AGENDA
Planning and Zoning Commission
March 20, 2024 – REGULAR MEETING

Meeting Date:	March 20, 2024	Meeting Title:	Planning Commission
Submitting Department:	Planning Department	Presenter:	Katelyn Page
Agenda Item:	Sketch Plan for 3-story hotel at 210 and 230 N. Glenwood Street (P24-018)	Public Comment:	Yes

Permit # P24-018 Parcel # : 22-41-16-28-4-07-011
Site Address: 210 N GLENWOOD STREET
Project Name: 210, 230 N. Glenwood - Glenwood Hotel - Sketch Plan

UPPER ROOF PLAN

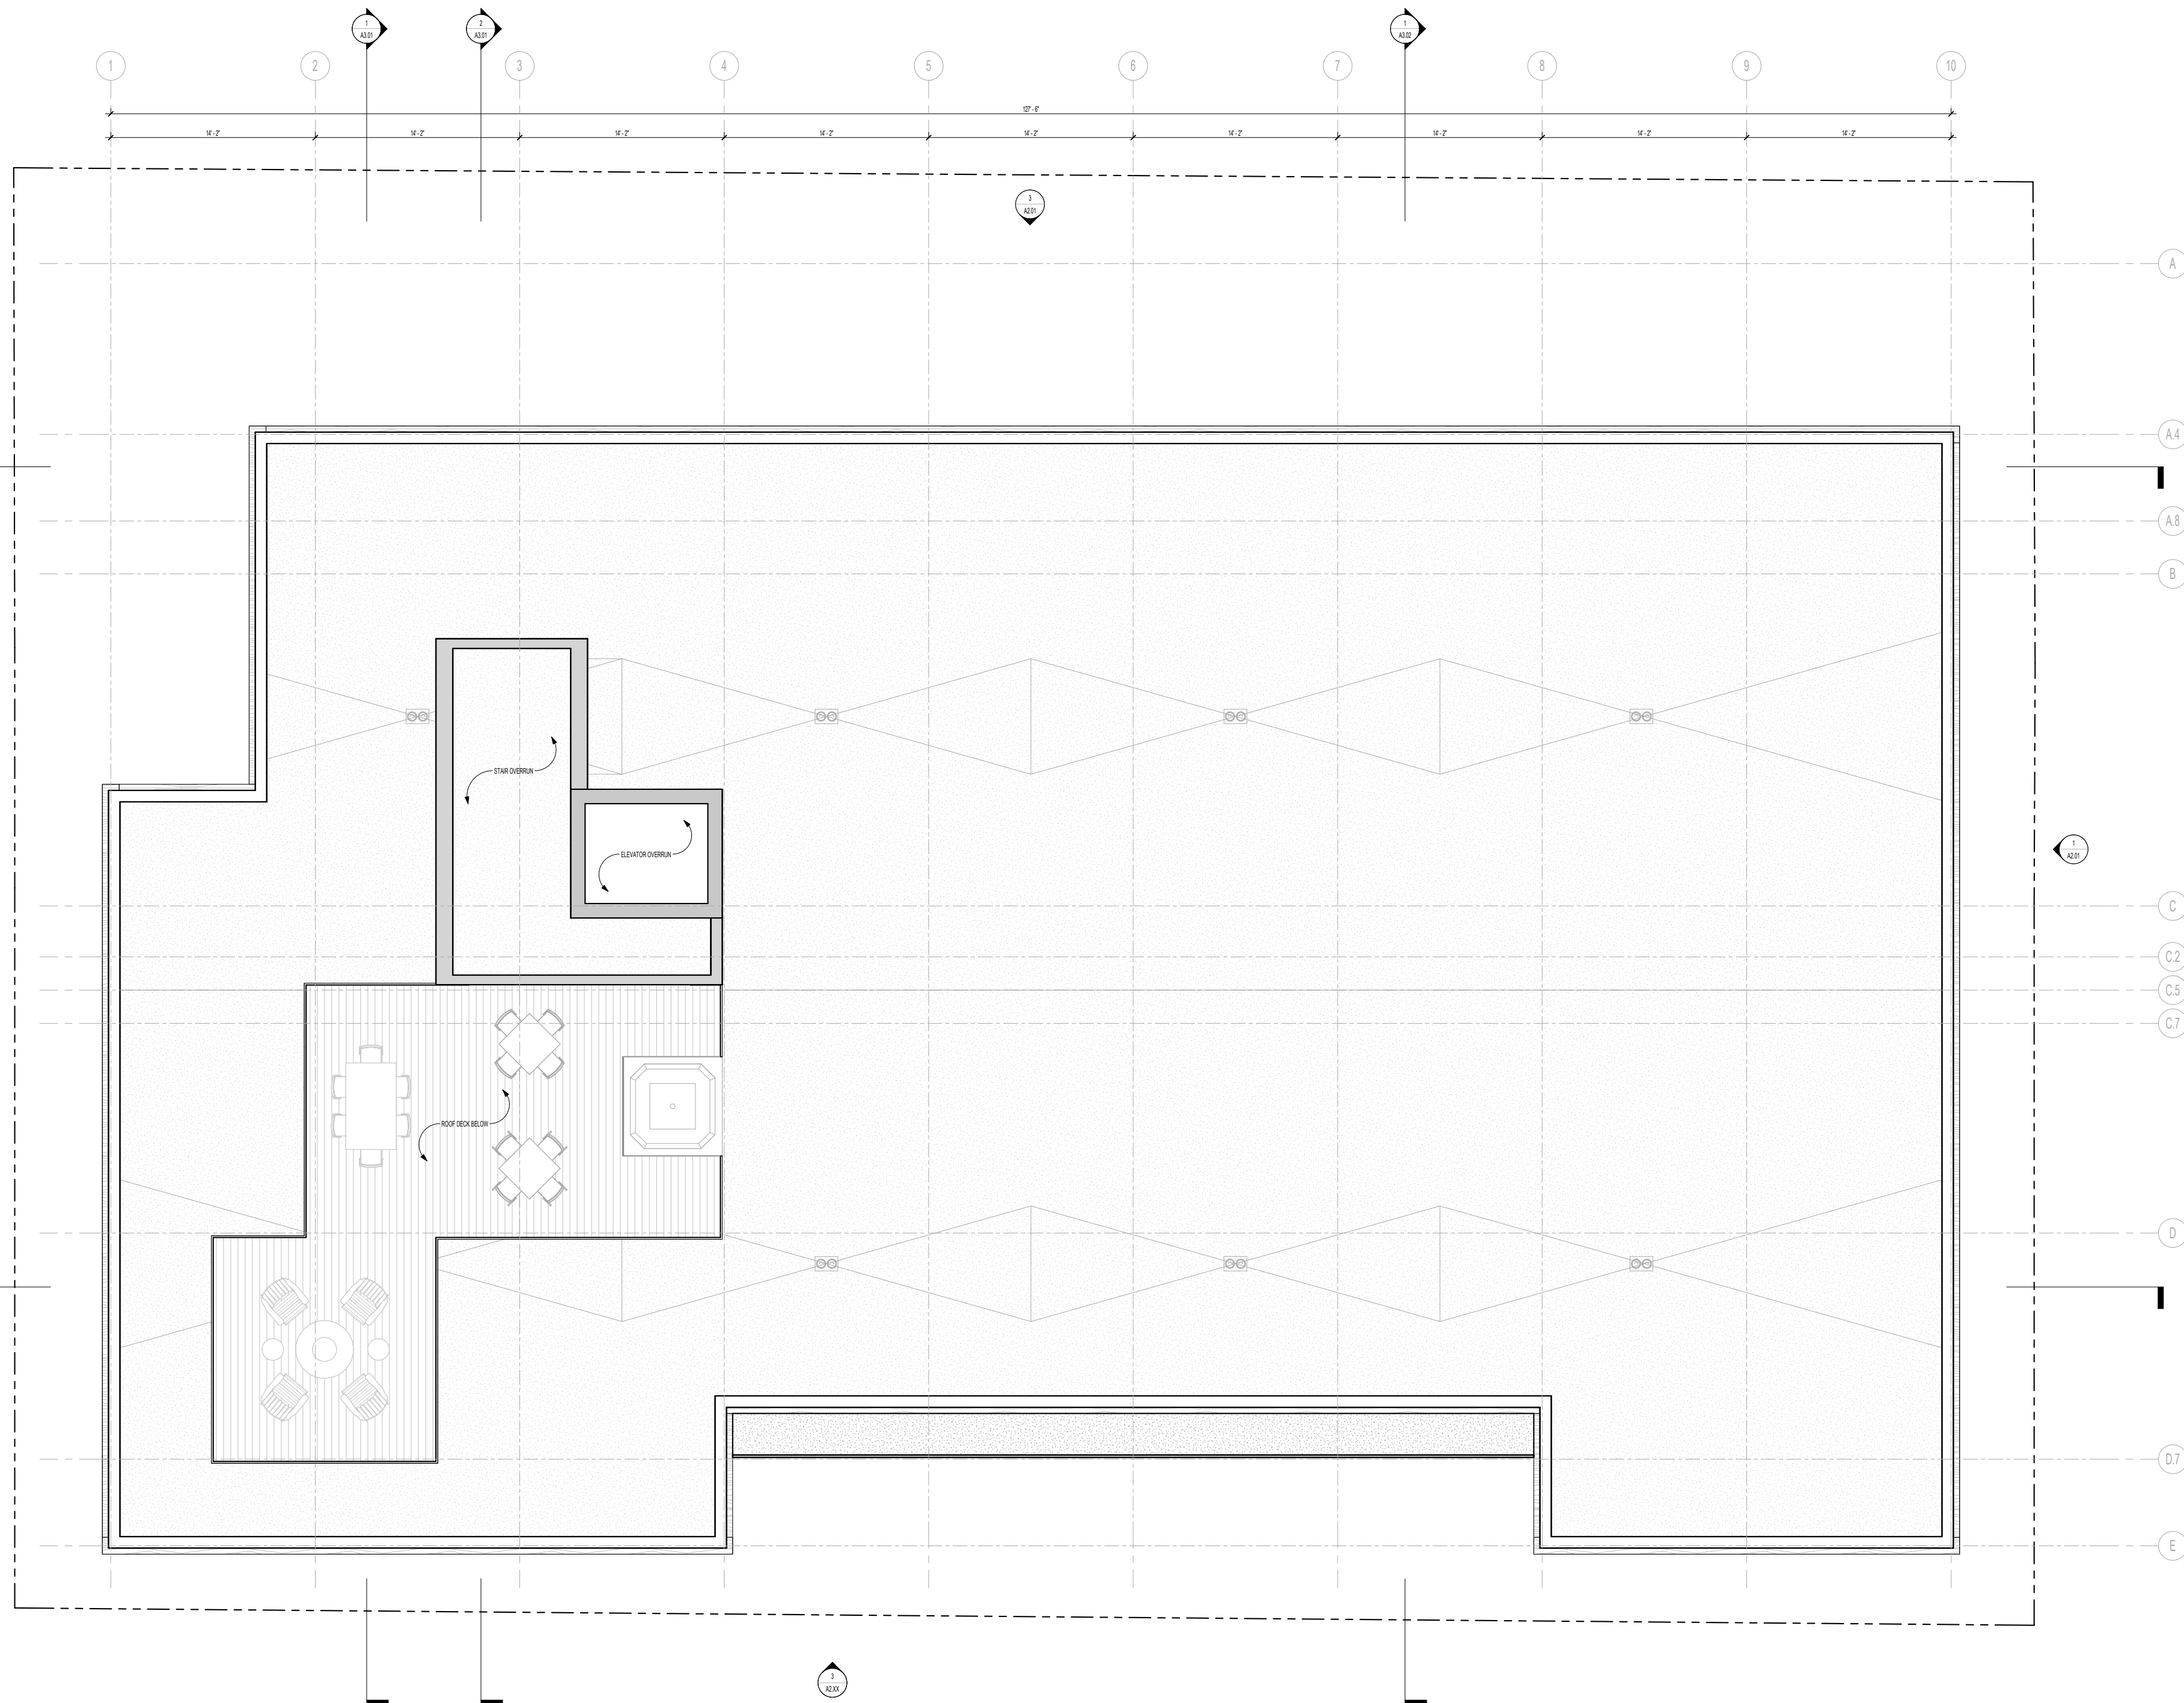
- As shown on plans A1.03, A1.50, A1.51 and A2.00, the structure has been revised to meet the 3rd floor setback requirements.
6. **Roof top mechanical room** - The proposed rooftop mechanical room exceeds allowed building height and is not included in height allowance for elements used exclusively for elevator or stairway access to a roof. Revise design prior to DRC and Sketch Plan submittal.

- As shown on plans A0.00, A1.50 & A1.51, the rooftop mechanical room has been removed.
7. **Roof height / deck / guardrail / pergola / deck furniture**
Current LDRS - Proposed design does not comply to current LDR height maximums. Under the current LDRs, structures used exclusively for elevator or stairway access to a roof may exceed the maximum allowable building height, provided they do not exceed the maximum height by more than ten feet, do not occupy more than 20 percent of the roof area, and are not visible from ground level view from a contiguous street (not limited to a right angle to the feature but all along the continuing street). Elements such as railings, furniture, hot tub, pergola structure may not exceed the max building height under current LDRs. The stair/elevator access components will need to be revised to meet the height allowance prior to DRC and Sketch Plan submittal.

EXTERIOR RENDERING – AERIAL VIEW, CORNER OF GLENWOOD & GILL

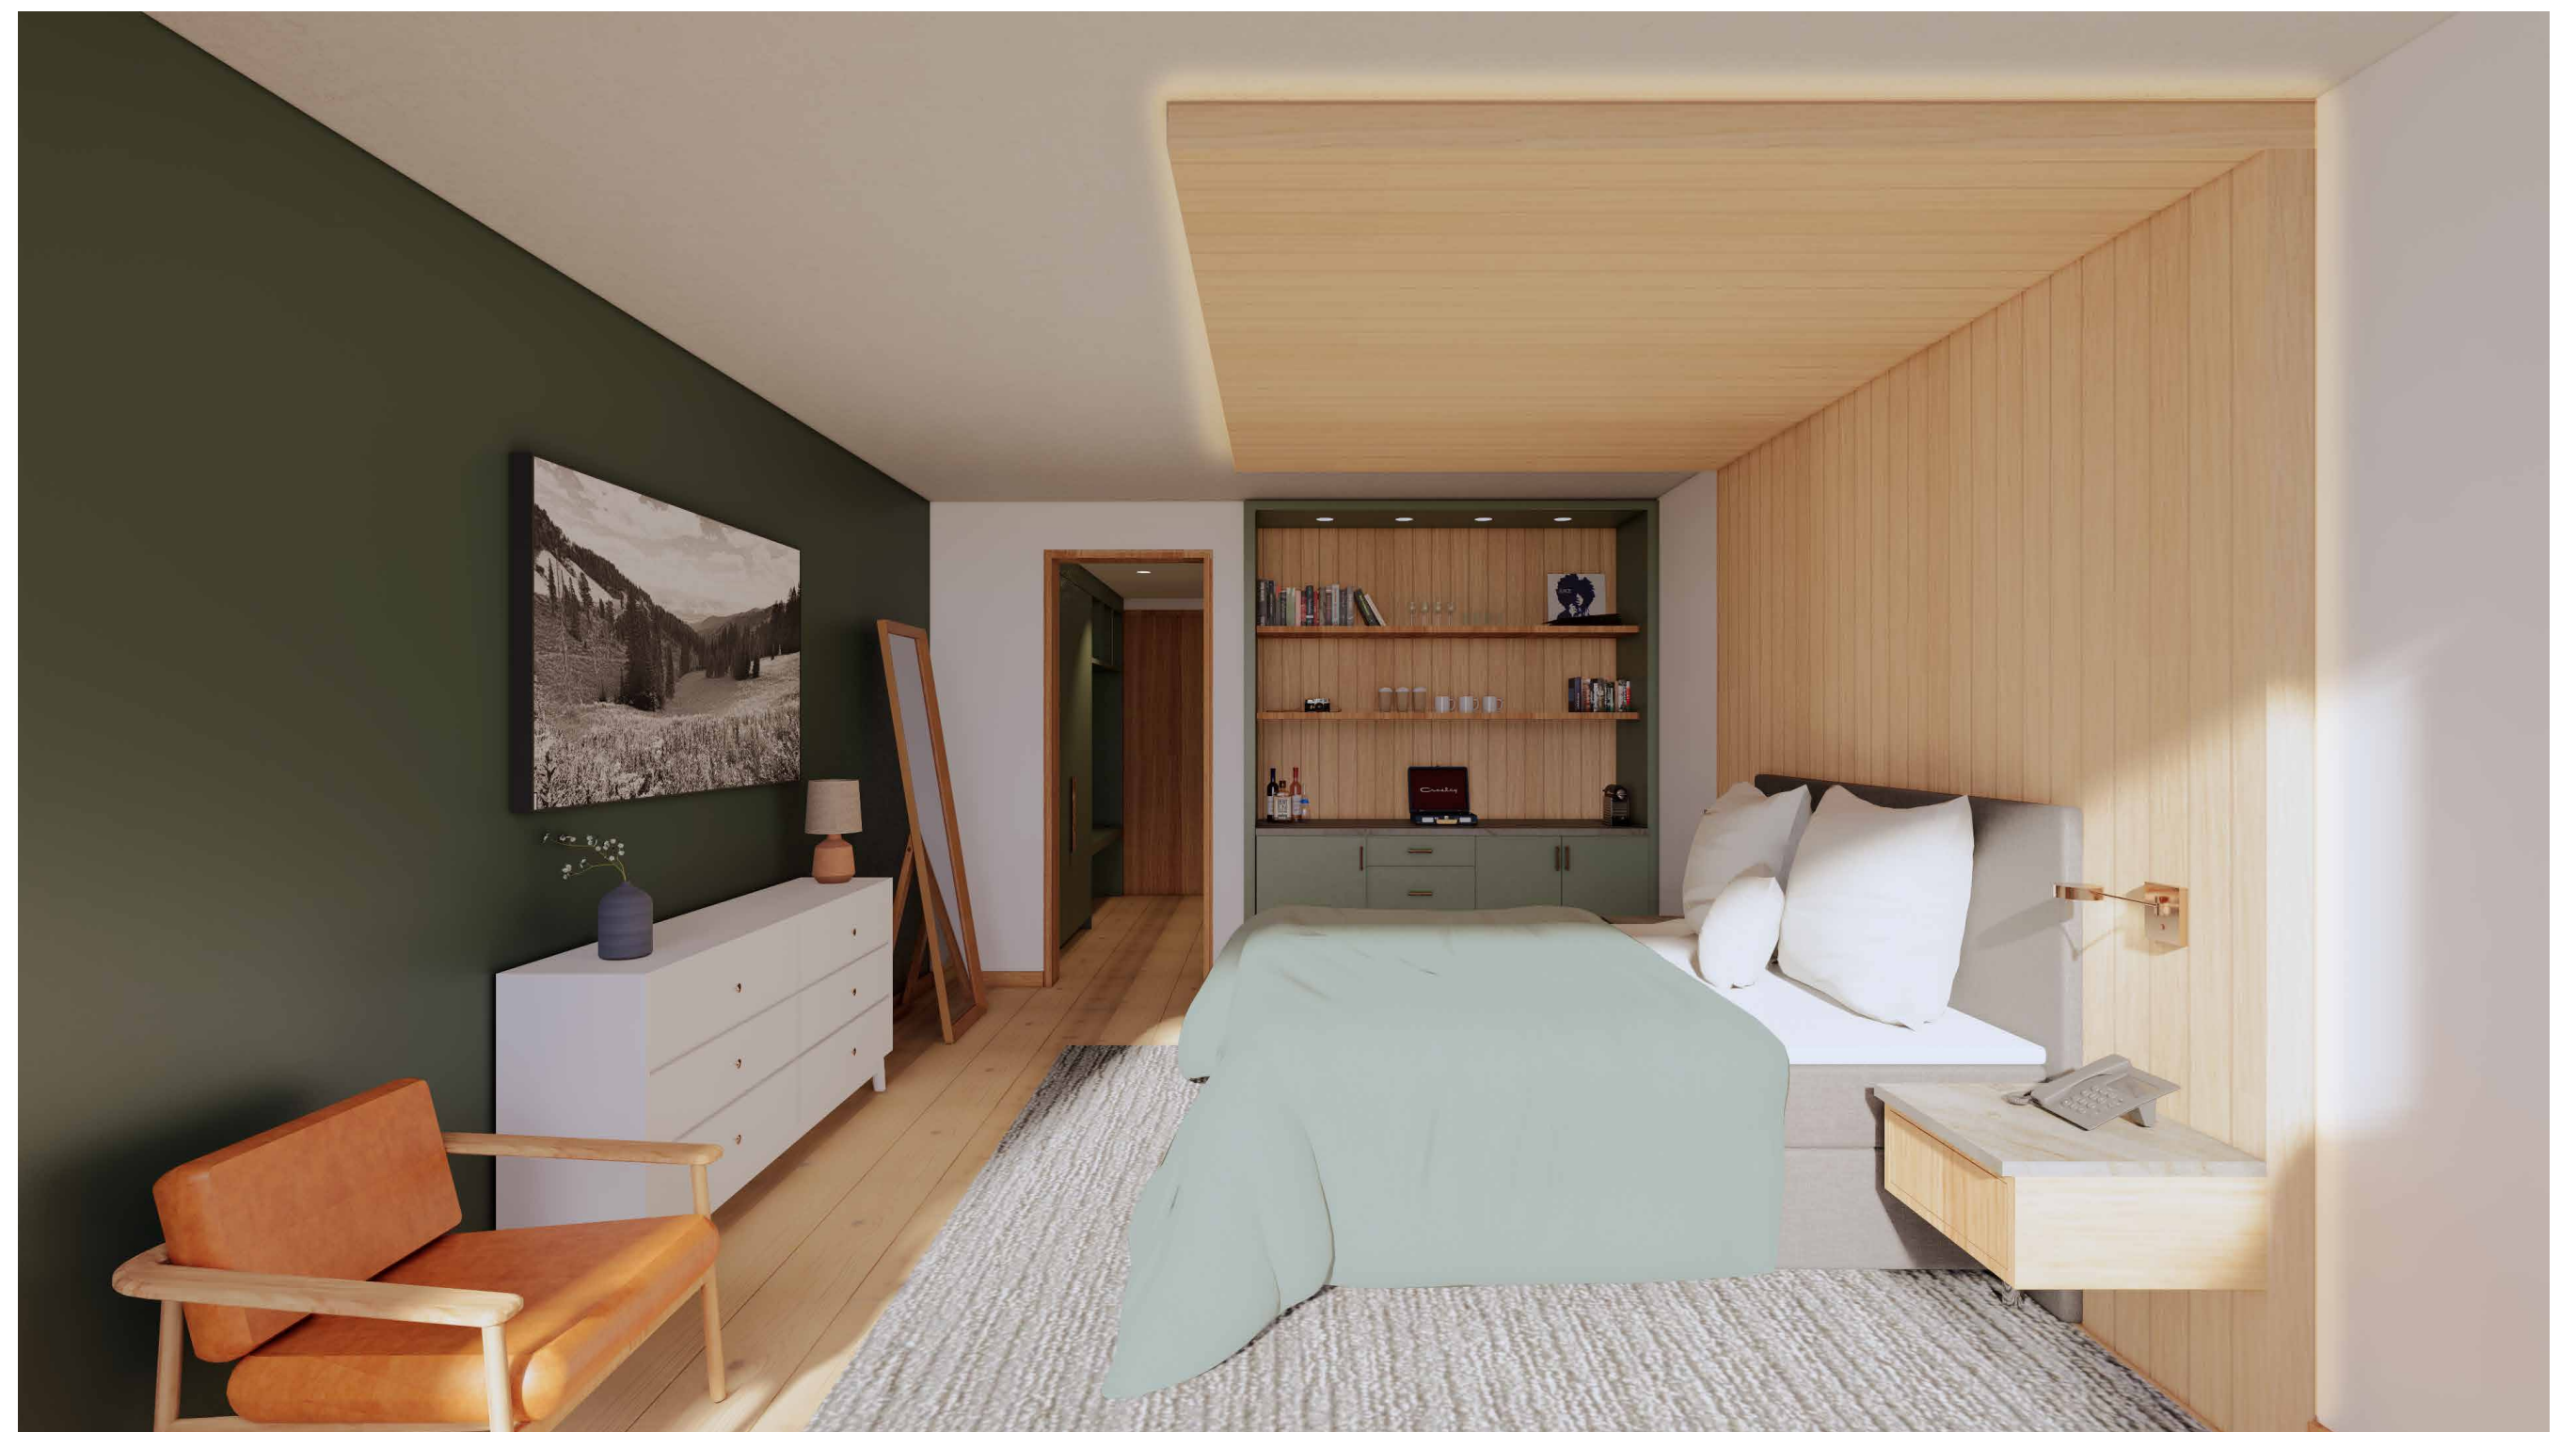
The applicant's Sketch Plan design was reviewed on March 13, 2024, by the DRC which recommended approval to Town Council (5-0) as presented with no conditions of approval. In general, DRC felt the building is well designed with appropriate scale, massing, and articulation for its context and well connected to the pedestrian experience at the property. There was positive feedback on material selection reflective of Jackson and local architecture. During its presentation to DRC, staff explained the applicant's alternative design renderings showing beams holding the third story at the northwest corner do not meet the LDR requirement for third story setback. As part of department review comments, staff request all renderings showing said beam be removed prior to Sketch Plan review by Town Council.

4. Revise submittal packet for rendering consistency Prior to Council review of sketch plan, applicant shall ensure architectural renderings show most recent updates to NW corner 3rd story beams and to roof level (ex: removal of outdoor kitchen sink, sunken spa, and removal of mechanical enclosure behind stair overrun)

THE DESIGN TEAM BELIEVES THAT THIS OPEN-AIR BEAM EXTENSION ALONG GLENWOOD STREET PROVIDES THE LIGHT, AIR & REDUCTION IN VOLUME THAT THE STEPBACK REQUIREMENTS PROMOTE – WHILE PROVIDING A MORE ELEGANT CORNER SOLUTION THAT TERMINATES THE STRUCTURAL GRID IN A MORE VISUALLY PLEASING MANNER.

SIZING WATER SERVICE LINES AND METERS

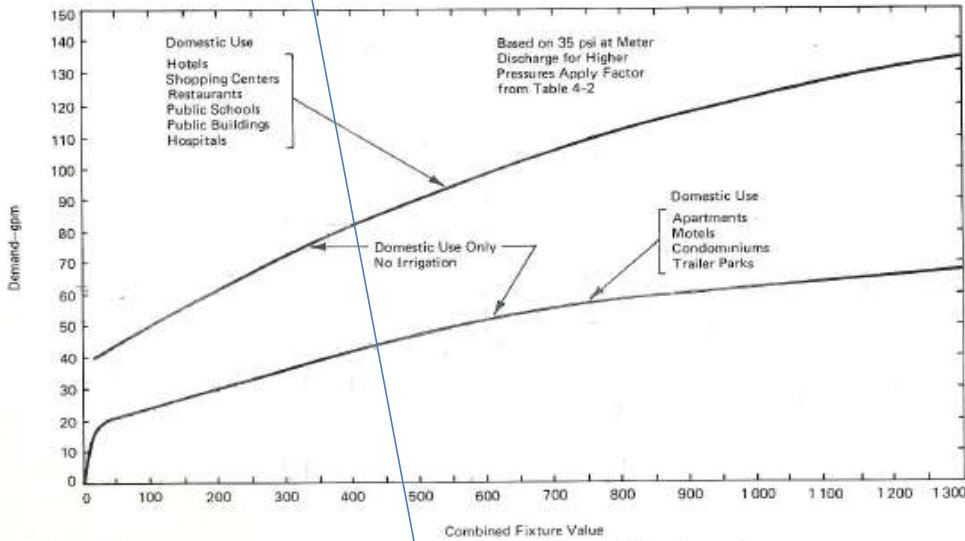
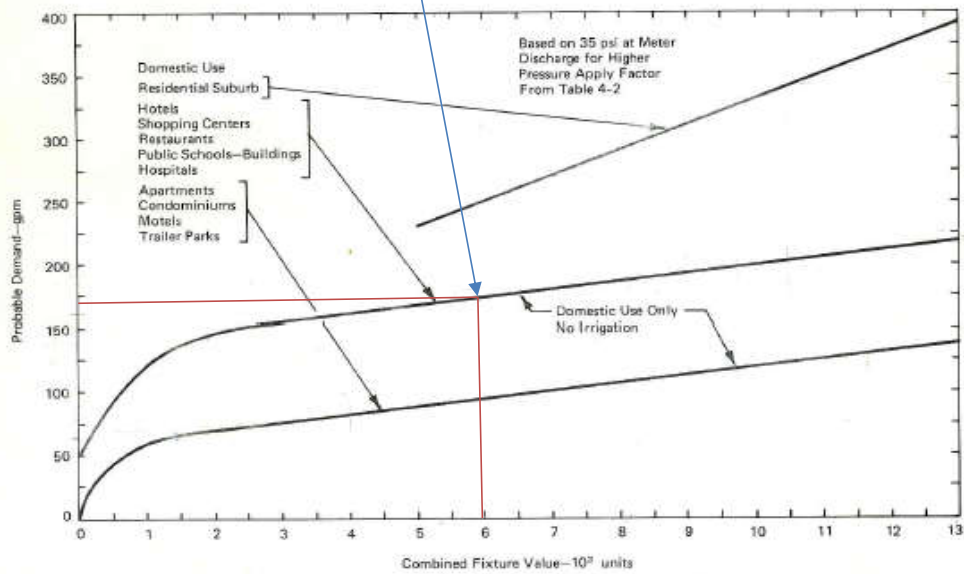
20. Review water AWWA M22 water demands. It looks like 6000 fixture units was used versus 600 fixture units. Revise accordingly.
